A123 SYSTEMS JSP17-21

Public Hearing at the request of Etkin, LLC for approval of Preliminary Site Plan, Woodland Permit, and Stormwater Management Plan. The subject parcel is located in Section 15, West of Cabaret Drive and South of Twelve Mile Road and is zoned OST, Office Service Technology. The applicant is proposing to develop the 31.25 acre parcel to two buildings: one office/lab space of 128,936 square feet and the other as assembly building of 53,469 square feet including associated site improvements.

PLAN REVIEW CENTER REPORT

Preliminary Site Plan

LANDSCAPE PLAN
FOUNTAIN OFFICE PARK
CITY OF NOV, OAKLAND COUNTY, MICHIGAN

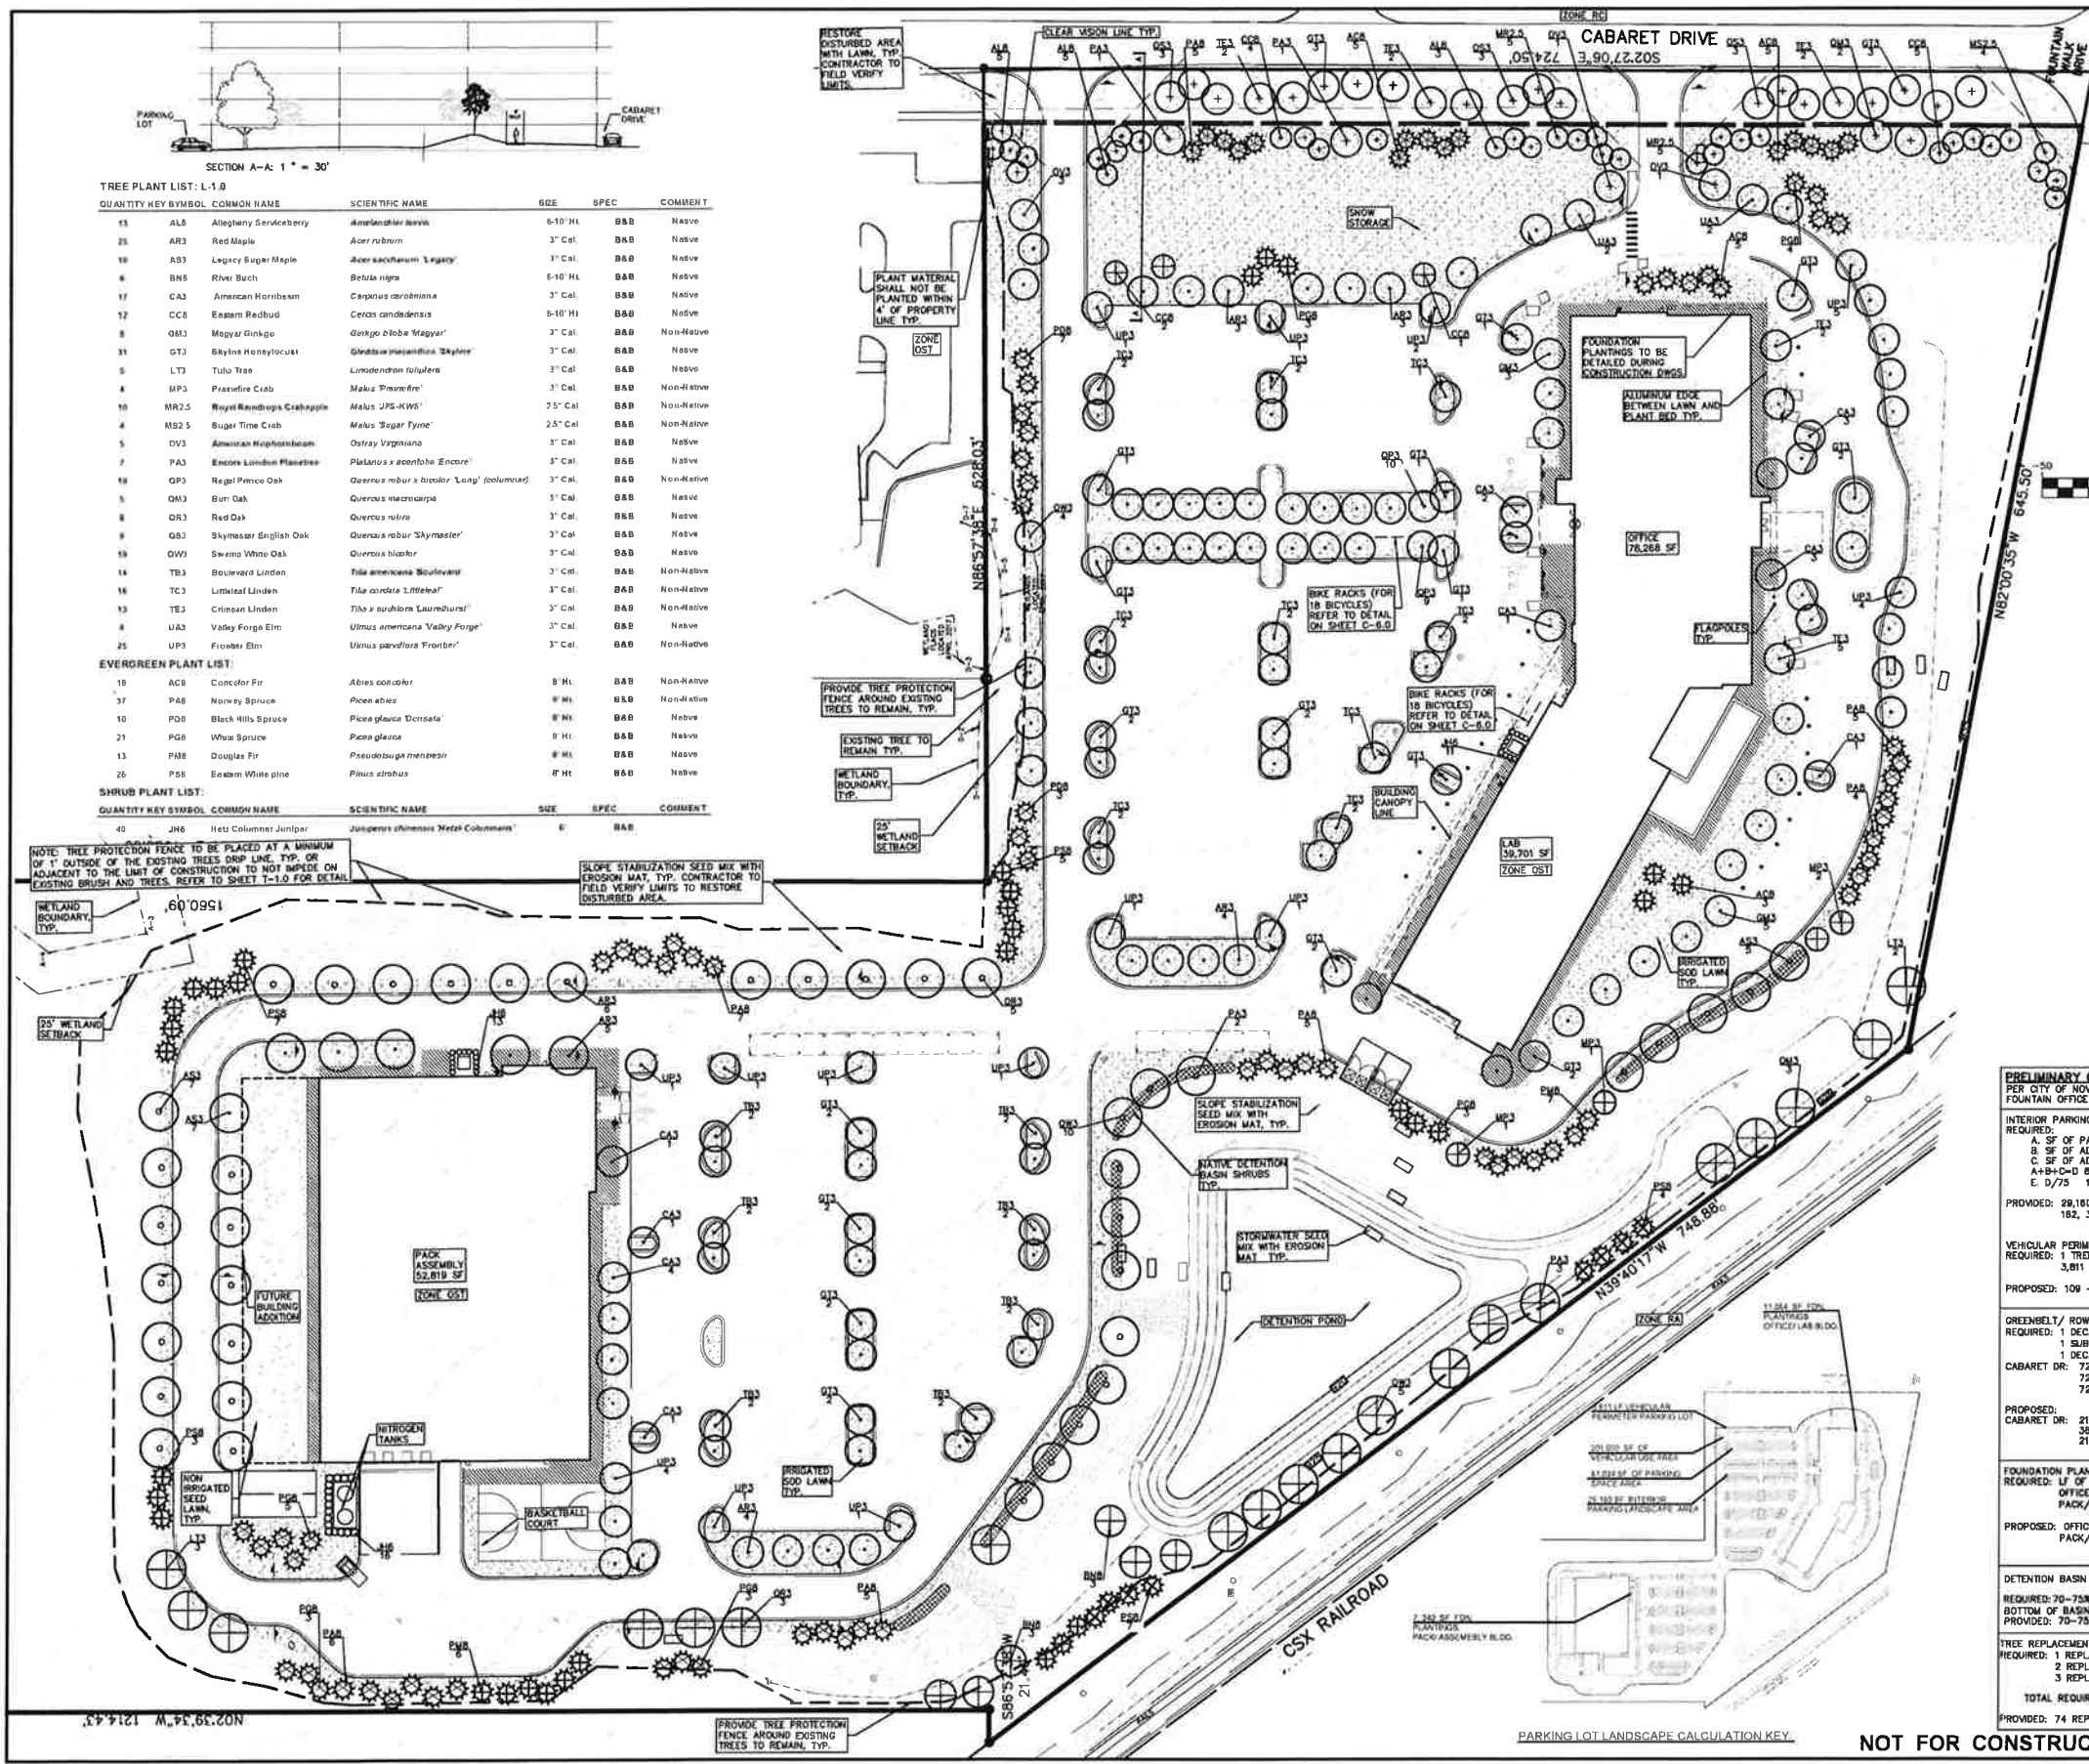
The Landscape Plan (Sheet L-1.0) states that the 74 required Woodland Replacement Trees will be provided on-site for the 64 regulated trees to be removed. It is not clear however which trees are proposed as Woodland Replacements. It appears as if some Tulip trees, red oak, river birch, swamp white oak, London Planetree, eastern white pine, Douglas fir, and white spruce are proposed as Woodland Replacements. Please review the City of Novi Woodland Tree Replacement Chart (attached) as some of the species of tree proposed as Woodland Replacement are not acceptable to the City (i.e., Douglas fir and London Planetree). The applicant shall review and revise the Landscape Plan and the associated Plant Schedule to list the quantities and species of Woodland Replacement Trees in table-form (i.e., indicate which trees are being proposed as Woodland Replacement trees in the *Tree Plant List*).

4. The Landscape Plan (Sheet L-1.0) states that the 74 required Woodland Replacement Trees will be provided on-site. It is not clear however which trees are proposed as Woodland Replacements. The applicant shall review and revise the Landscape Plan and the associated Plant Schedule to list the quantities and species of Woodland Replacement Trees in table-form (i.e., indicate which trees are being proposed as Woodland Replacement trees in the *Tree Plant List*).

Figure 1. City of Novi Regulated Wetland & Woodland Map (approximate project boundary shown in red). Regulated Woodland areas are shown in green and regulated Wetland areas are shown in blue.

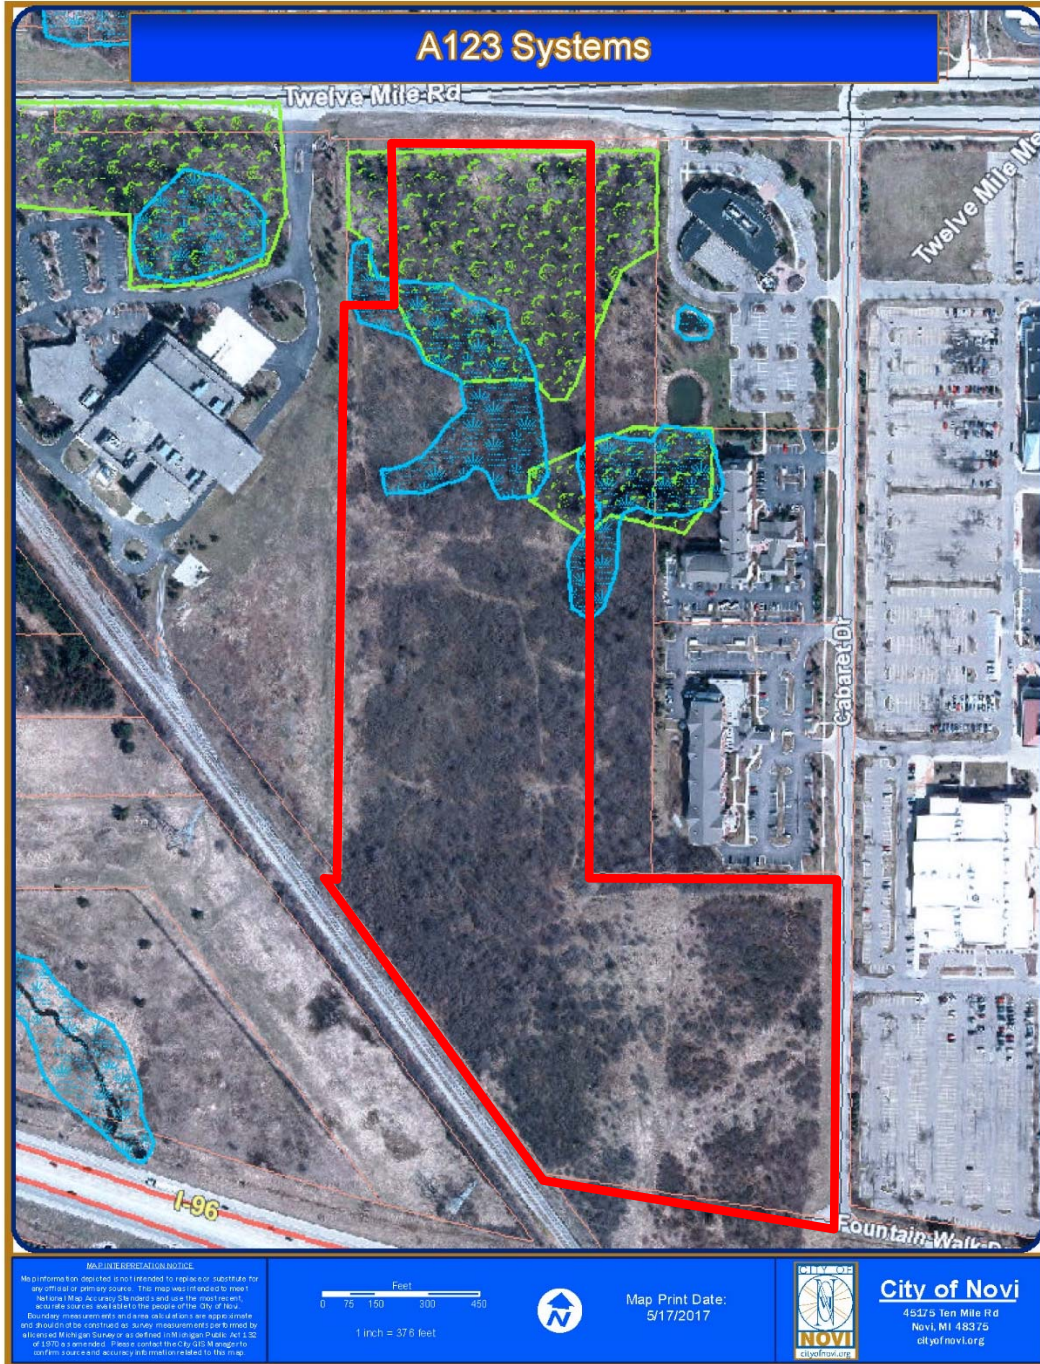
Based on our review of the Plan, Novi aerial photos, Novi GIS, the City of Novi Official Wetlands and Woodlands Maps (see Figure 1, attached) it appears as if this proposed project site contains City-regulated wetland areas. These wetland areas are concentrated in the northern portion of the subject site.

As noted above, the site does contain area mapped as City regulated wetland (Figure 1). The focus of the inspection was to review site conditions in order to determine whether on-site wetlands are considered regulated under the City of Novi's Wetland and Watercourse Protection Ordinance. Wetland boundary flagging was in place at the time of this site inspection, however it is not clear how recently the wetland delineation had been completed on the site. ECT concurs with the wetland areas as indicated on the Plan. These wetlands appear to be accurately flagged in the field. The two (2) existing wetland areas also appear to be accurately indicated on the Plan.

FIGURE 2 EXISTING TRAFFIC VOLUMES

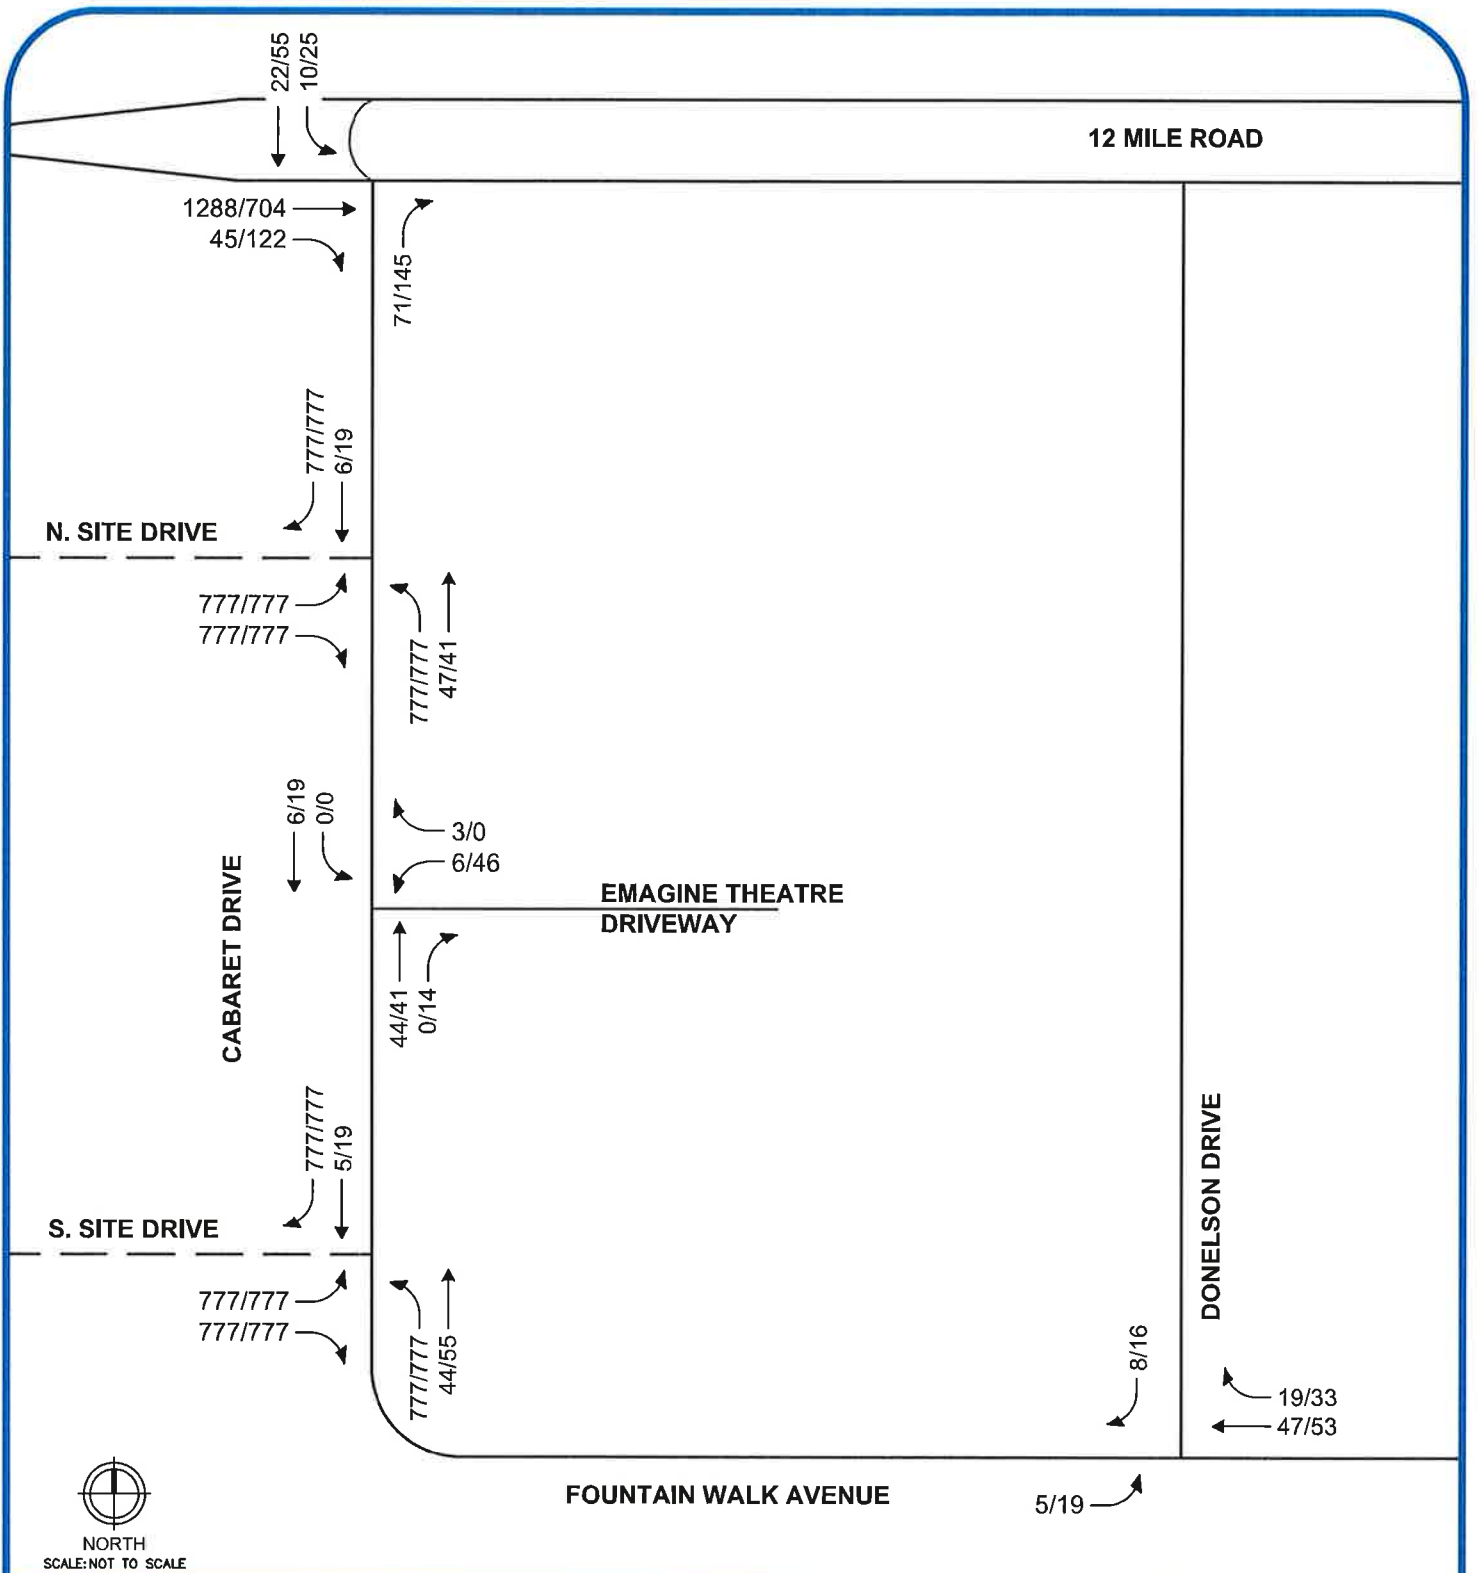
4. Figures 2 and 3 should be updated to disinclude the "777/777" to indicate that turning movements are not applicable at that location for that figure.

FIGURE 3 BACKGROUND TRAFFIC VOLUMES

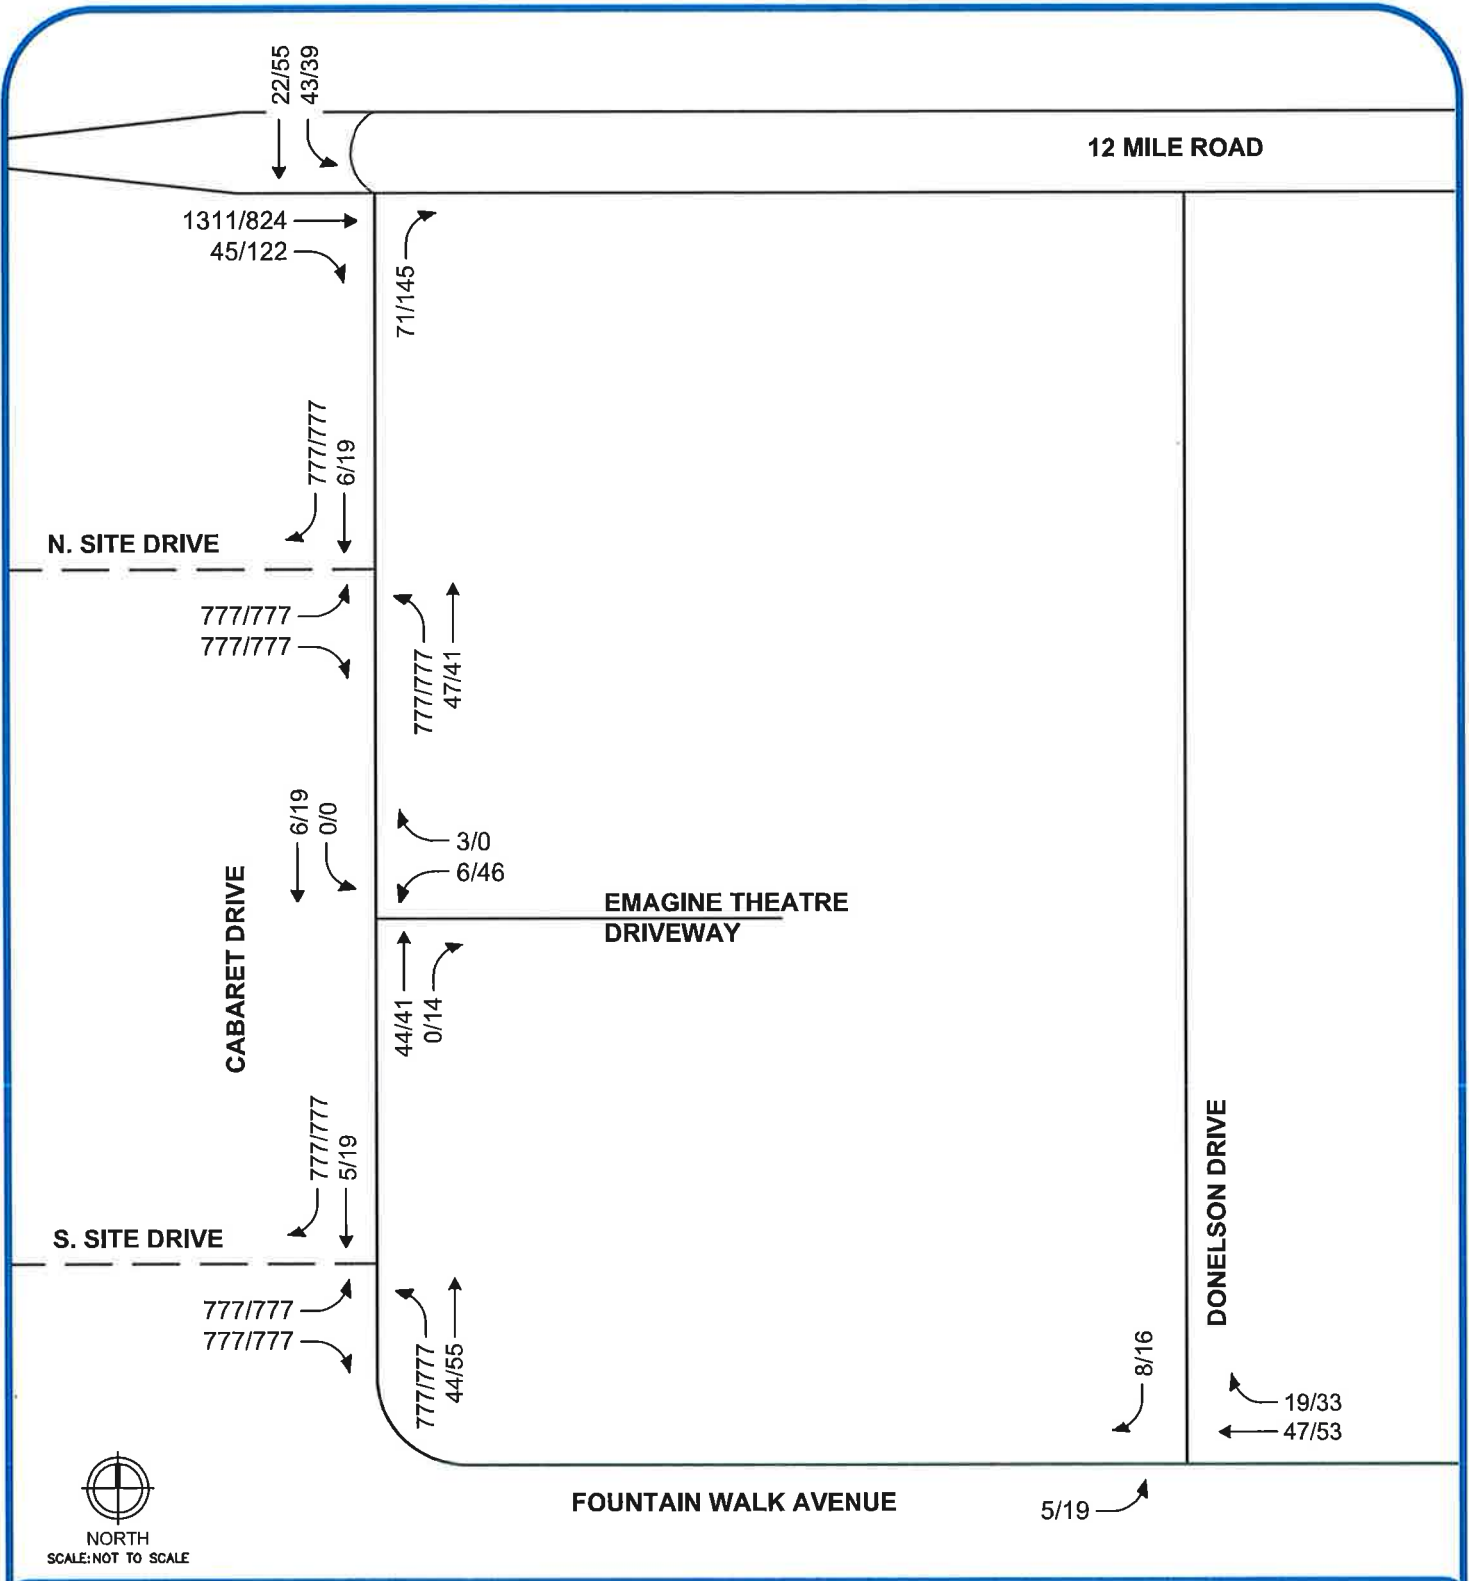
4. Figure 3 should indicate that existing traffic volumes are also included in the turning movement counts.
5. The results of the background traffic analysis indicate that the intersection of 12 Mile Road and Cabaret Drive will operate in a similar manner to existing conditions and increases in delay from future developments is minimal. This was the only study intersection affected by background traffic. All other study intersections are expected to operate as described in existing conditions.
